## **Updated Scoping Opinion**

**Scoping Opinion on behalf of Scottish Ministers under the  
Electricity Works (Environmental Impact Assessment) (Scotland)  
Regulations 2017**

**Hagshaw Energy Cluster – Western Expansion  
Spirebush Ltd, subsidiary of 3R Energy Solutions Limited**

**17 May 2024**

Figure 1: Proposed development location shown on an airways chart

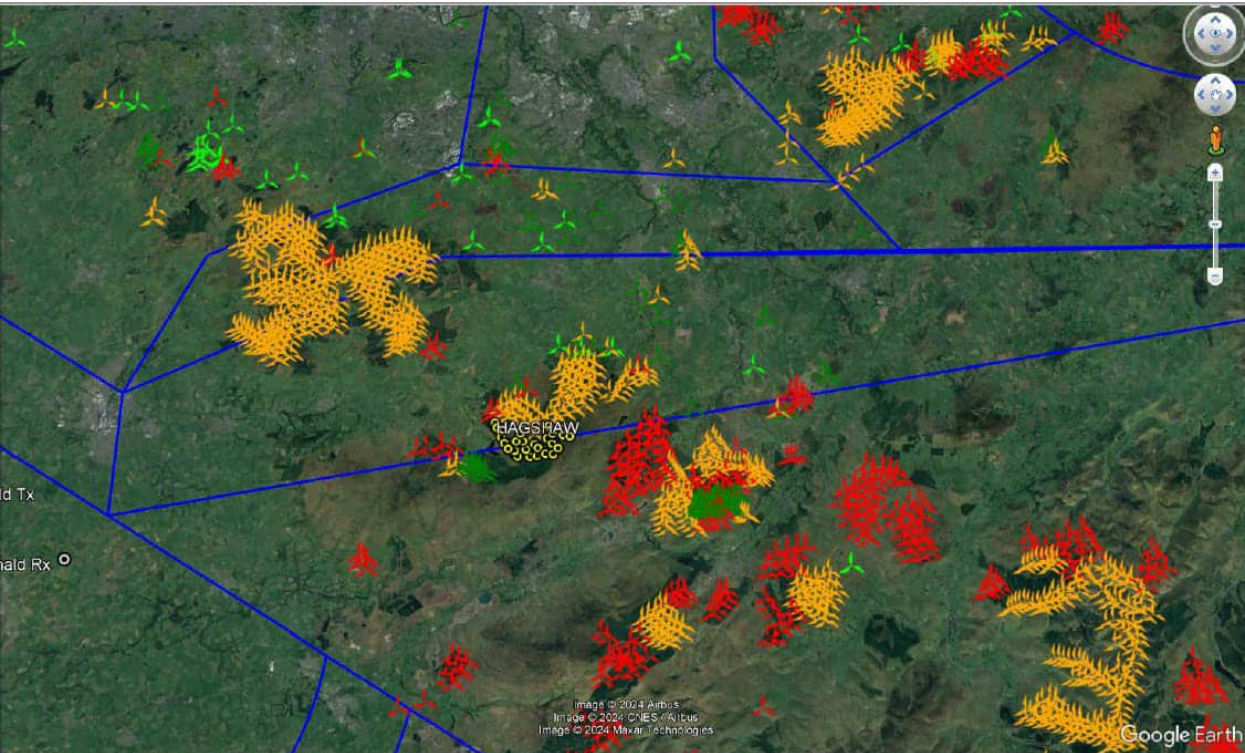
All terrain and propagation modelling is carried out by a software tool called ICS Telecom (version 11.1.7). All calculations of propagation losses are carried out with ICS Telecom configured to use the ITU-R 526 propagation model.
